**E-54 Regional Lift Station - RFCSP
Solicitation Number: CO-00537
Job No.: 22-2502**

**ADDENDUM 2
October 25, 2022**

SAWS JOB NO.	22-2502
JOB NO.	11500-51
DATE	SEPTEMBER 2022
DESIGNER	KB
CHECKED	KB
DRAWN	GL
SHEET	E10.10

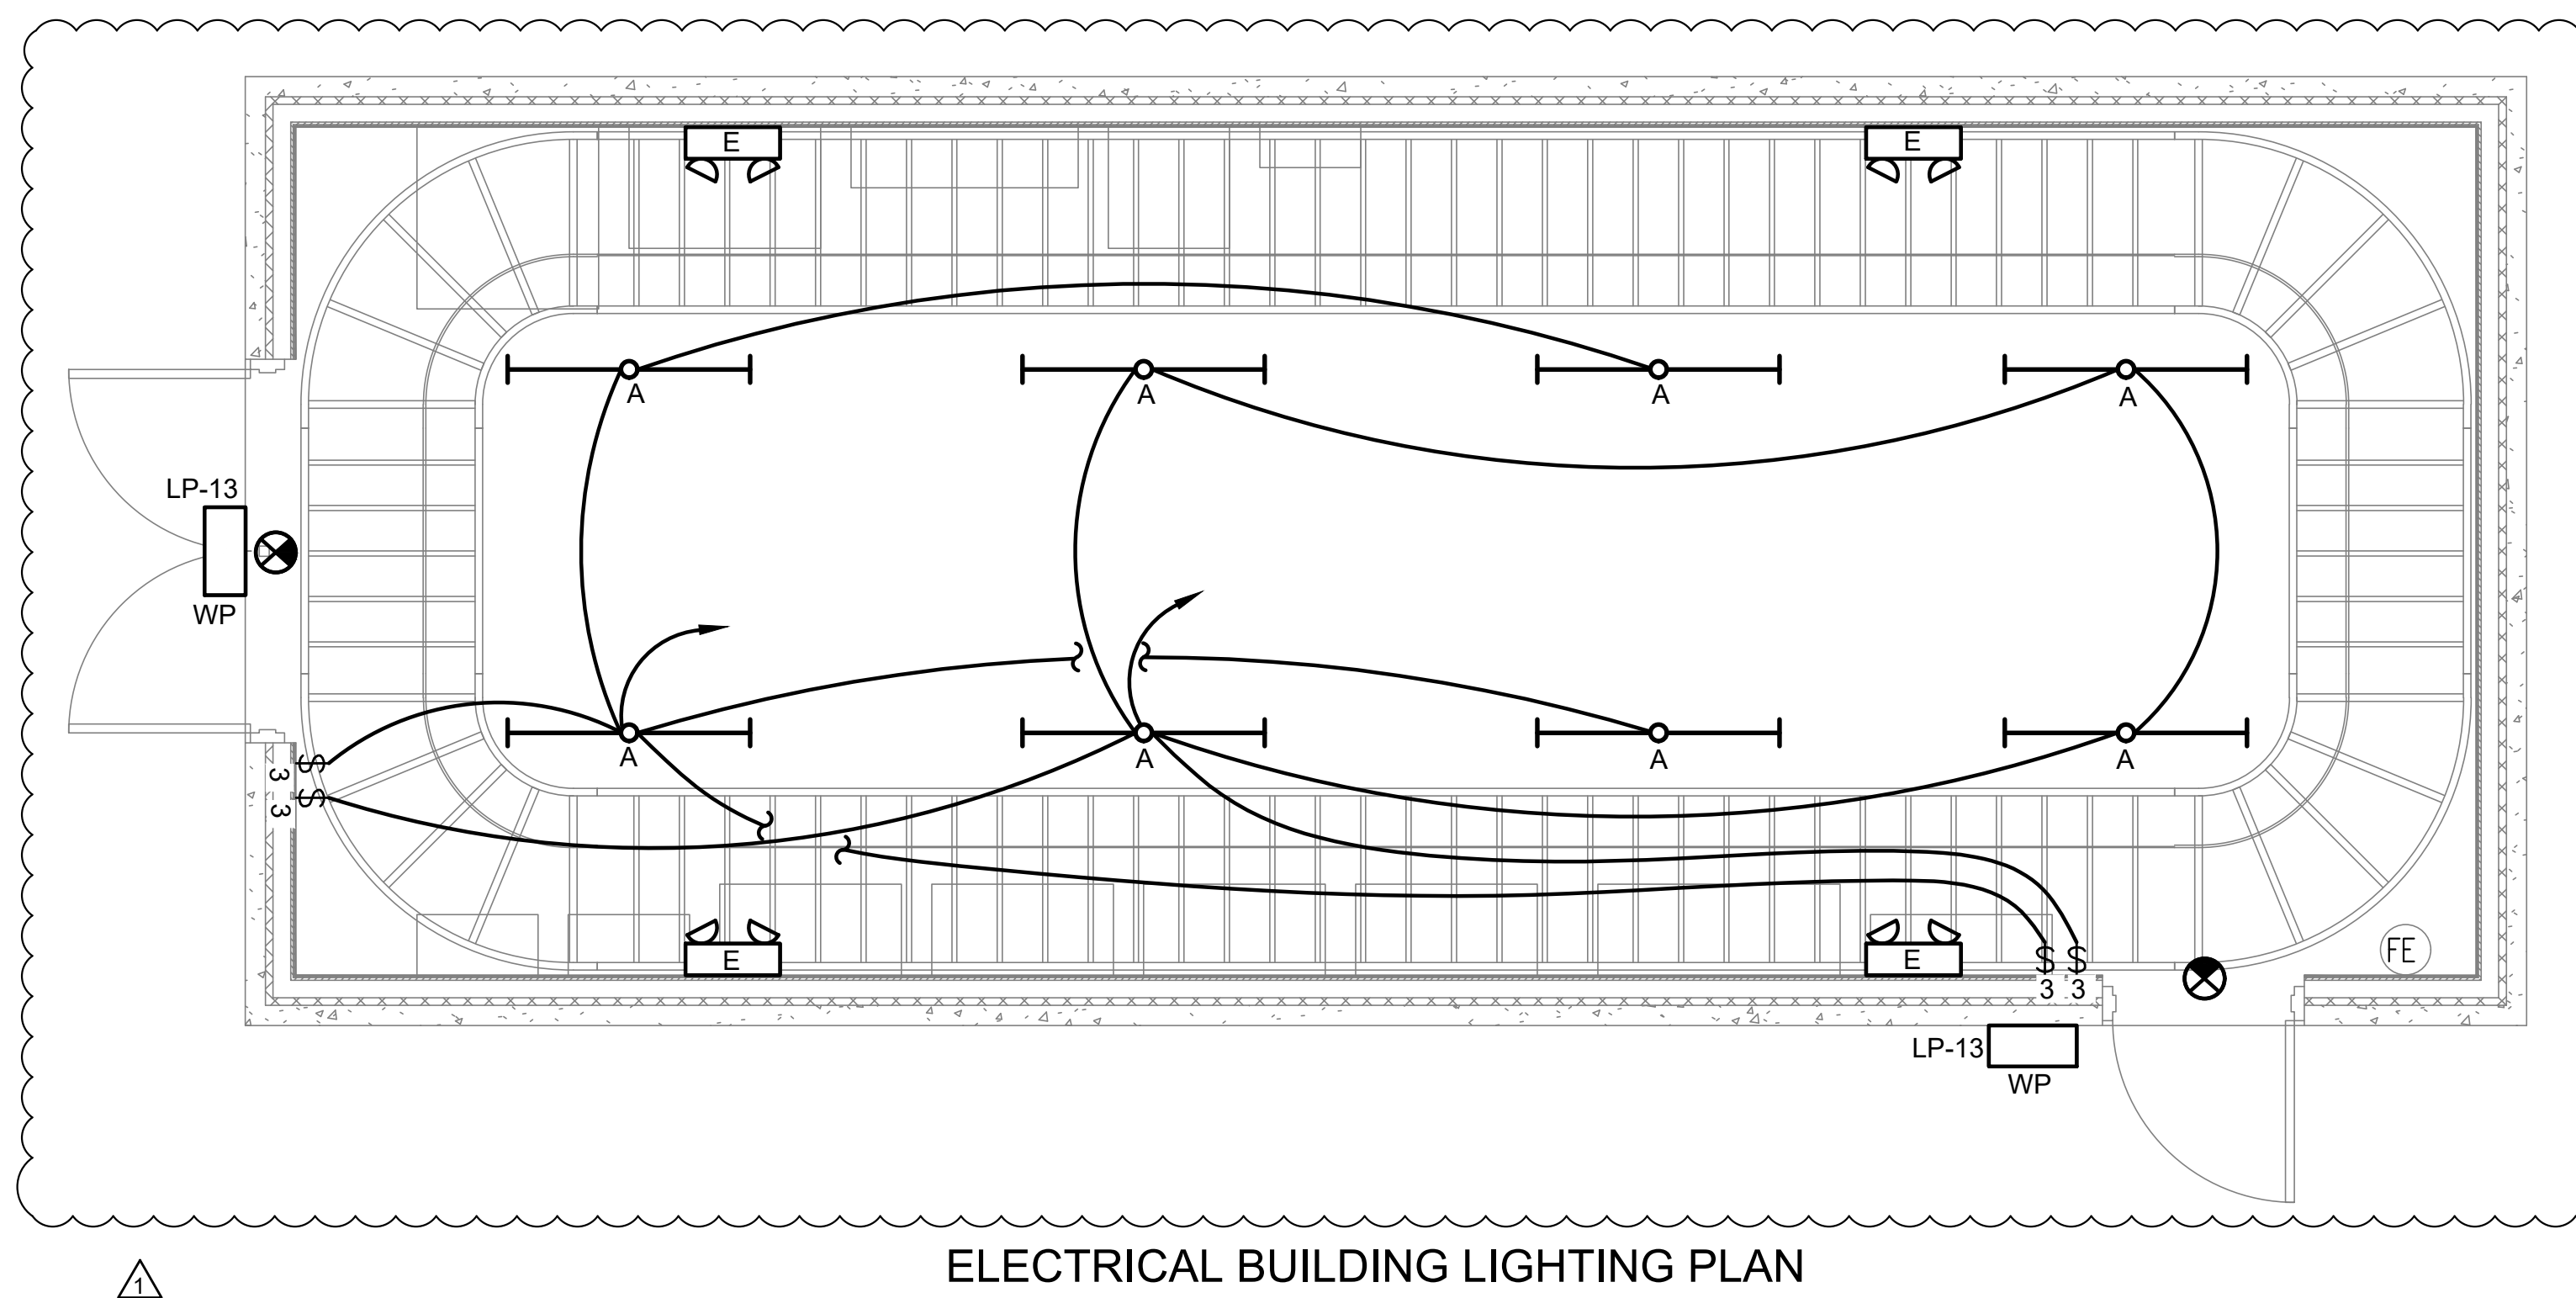
Fixture Schedule on E3.50 shows Type E- Emergency Lighting but the lighting plan on E10.10 does not show any. Please clarify.

Neither Sheet E10.10 cable tray plan nor specification section 16115 addresses the requirements for cable tray barriers to segregate power, control, and instrument cables. Please clarify.

RESPONSE: Sheet E10.10 is revised to show the addition of 4 emergency wallpack fixtures, two additional three way switches, and revised light circuits. Interior emergency wallpack fixtures and exit signs are now circuited to LP-2. Refer to Sheet E3.50 for updated panel schedule with new circuits. See Changes to the Plans #8 and #12.

RESPONSE: Sheet E10.10 revised to show a 42 inch wide tray with a barrier dividing a 24 inch wide power section from an 18 inch wide controls/instrumentation section. See Changes to the Plans #12.

SAWS JOB NO. 22-2502
 JOB NO. 11500-51
 DATE SEPTEMBER 2022
 DESIGNER KB
 CHECKED KB DRAWN GL
 SHEET **E10.20**

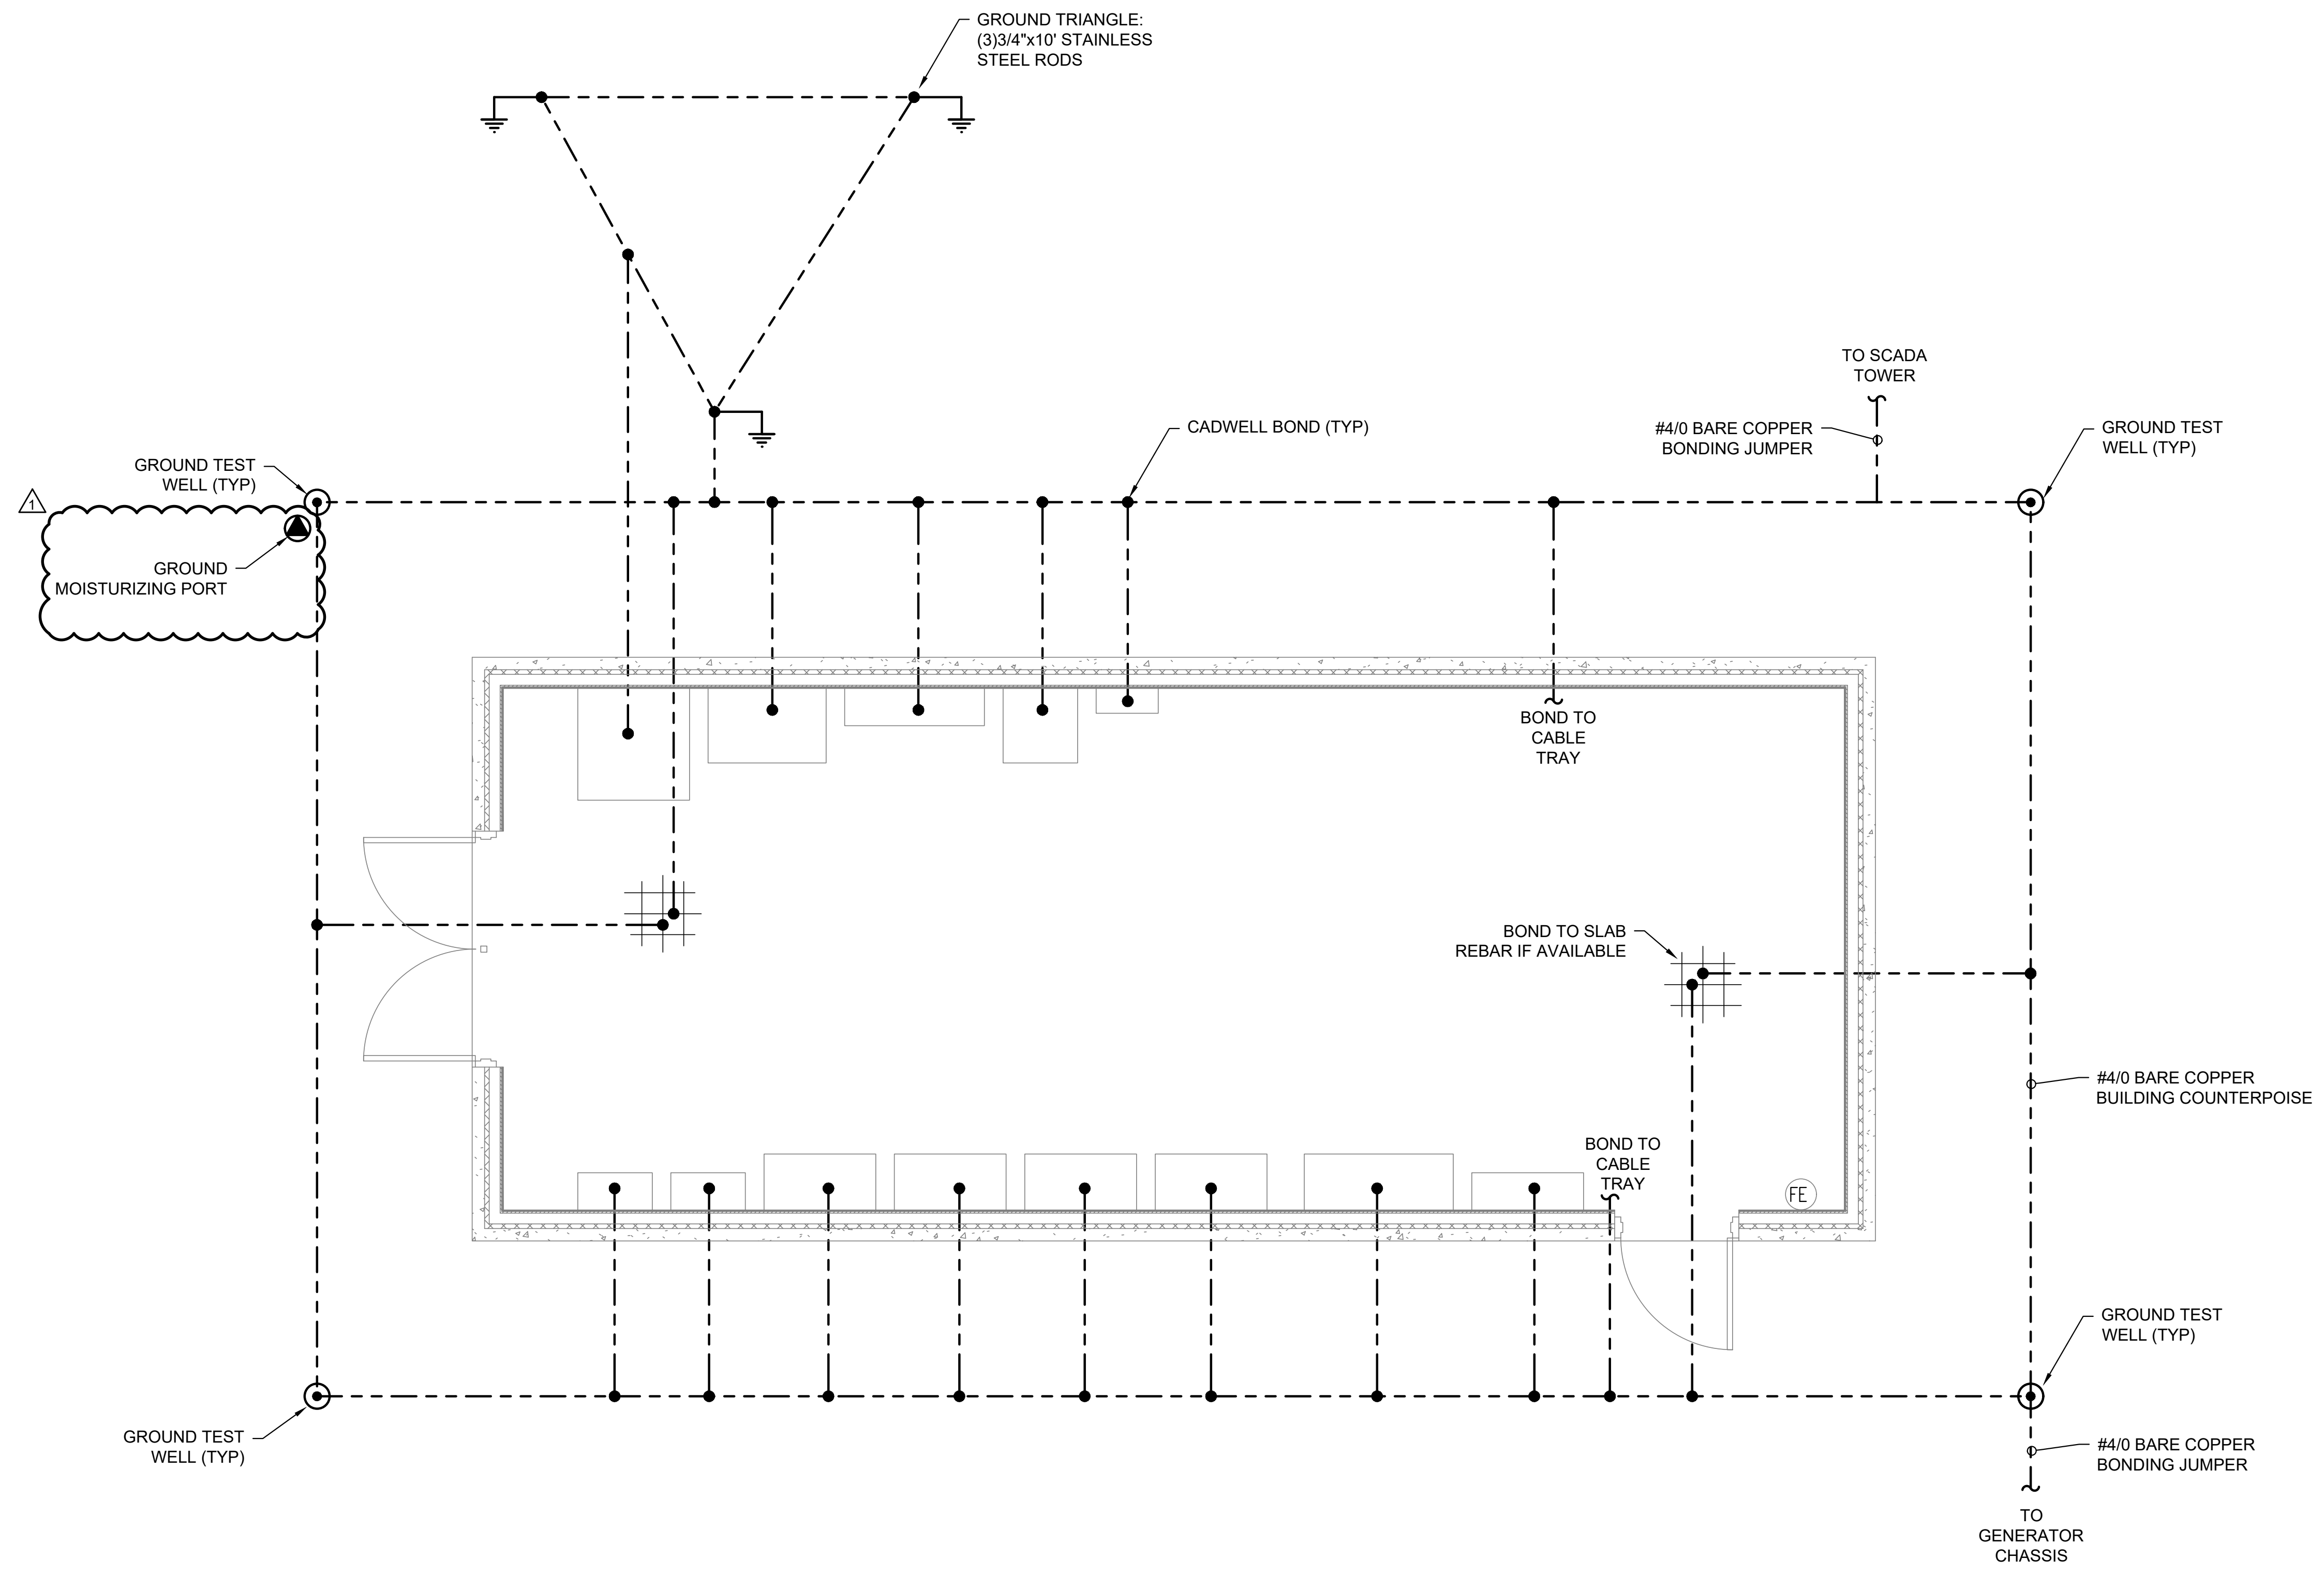
Sheet E11.08 shows ground moisturizing port for the generator, no other drawings show ground moisturizing port associated with test wells or ground rods. Please clarify if ground moisturizing ports are required for the remainder of the project site.

RESPONSE: Sheet E4.00 is revised to show additional moisturizing ports at the following location: near the meter rack, at the generator and at the electrical building. Sheet E10.20 revised to show an enlarged of the moisturizing port at the electrical building. Sheet E11.00 revised to show new ground moisturizing port and test well detail 6. See Changes to the Plans #9, #13, and #14.

SAWS JOB NO.	22-2502
JOB NO.	11500-51
DATE	SEPTEMBER 2022
DESIGNER	KB
CHECKED	KB
DRAWN	GL
SHEET	E11.00

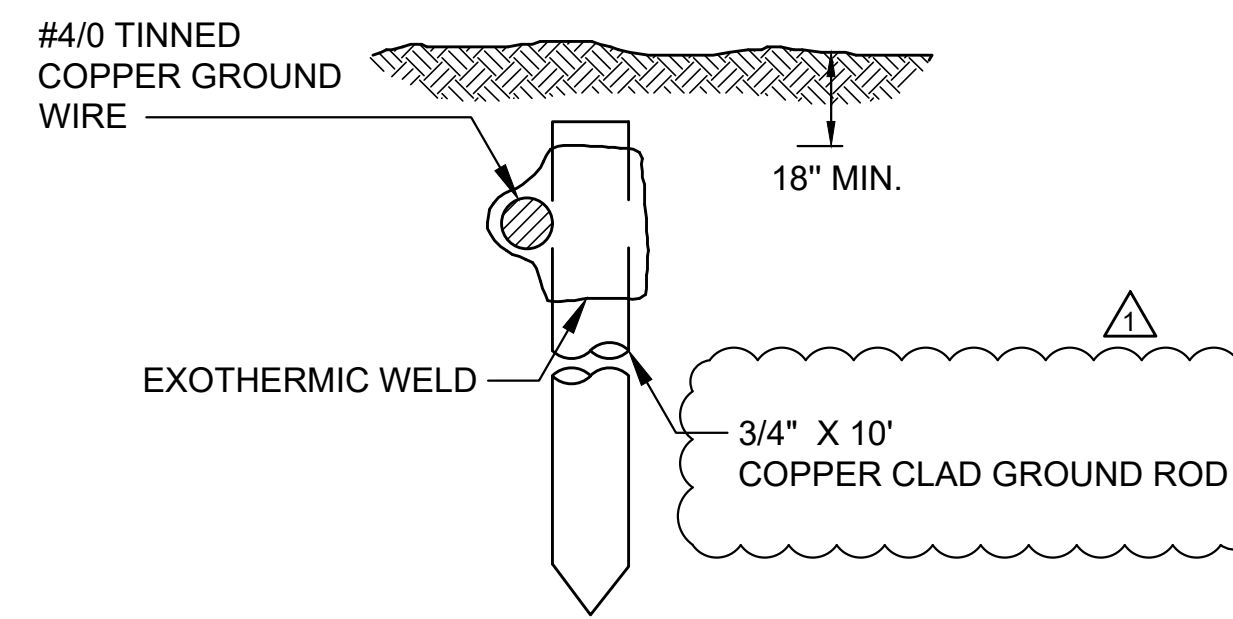
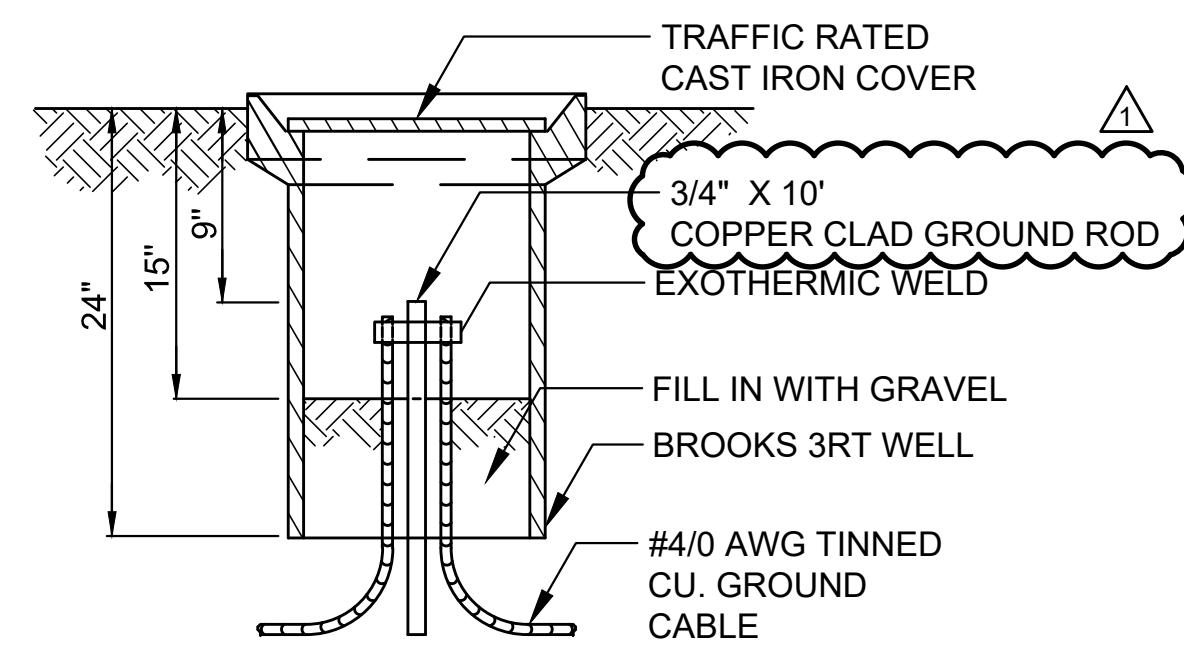
Specification Section 16660 2.01 D as well as other specification sections call for ground rods to be 3/4" x 10' copper clad, however Sheet E11.00 detail 3 & 5, specifies 3/4" x 10' stainless steel ground rods. Please clarify.

RESPONSE: Replace Specification 16660 with Specification 16451, which states ground rods shall be copper clad. Sheet E11.00 details 3 and 5 revised to show copper clad rods. See Changes to the Plans #14.
